DUKE POWER COMPANY

August 23, 1985

Regarding: Catawba Nuclear Station
Docket No. 50-413 and 50-414
Resolution of Outstanding Items on Diesel Generators

FIGURE 1. CYLINDER HEAD REPAIR

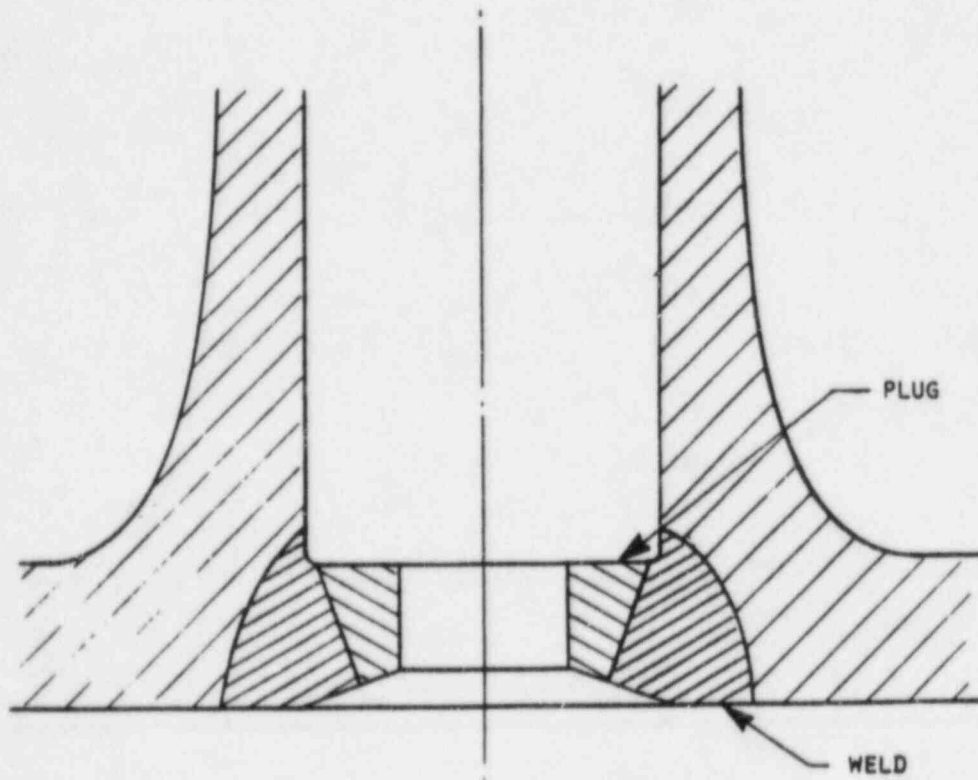
Four cylinder heads at Catawba, one on engine 1A and three on engine 1B, developed small jacket water leaks into the fuel injection cavity. The 1A cylinder head has been examined by FaAA. This investigation (reference 3) revealed that the leak was caused by a crack initiating from the corner of a welded-in plug where it was seated in the cylinder head as shown in Figure 1A. This welded-in plug is reported by TDI to have been used to repair the casting around the fuel injector hole. This head as well as the three heads on engine 1B were replaced. Reference 2, forwarded by reference 1, requested that Duke Power Company replace another head on diesel 1A (head 6L) where it was suspected, based on visual examination, that this head had the same welded-in plug. This head was subsequently replaced on diesel 1A. The remaining heads on both engines were inspected and we therefore believe that none of the cylinderheads on the Catawba Unit 1 diesels have weld repairs.

Results of both visual and ECT inspections on diesel 2A showed that five heads had been repaired with partial penetration welds. These heads have been replaced. Of the heads replaced three heads (cylinders 6L, 7L and 8L) are heads with no weld repair. The other two replacement heads (cylinders 2R and 3R) have been repaired per Figure 1B. Results of the same inspections on diesel 2B showed that no heads had plug repair welds.

Referring to Figure 1B, the weld repair of the cylinder heads consists of welding a plug into the head, stress relieving the weld and machining the injector port back side of the plug out such that the repair is a full penetration weld. This repair is described on TDI drawing 102718, Rev. 0. Cylinder heads at Catawba that have been repaired in this fashion are stamped 1NR. The full penetration weld eliminates the crack starter found in previous partial penetration weld repaired heads. Post weld stress relieving reduces welding residual stresses to low levels. Thus, weld repaired castings with full penetration welds which are stress relieved are considered equivalent in quality to non weld repaired castings.
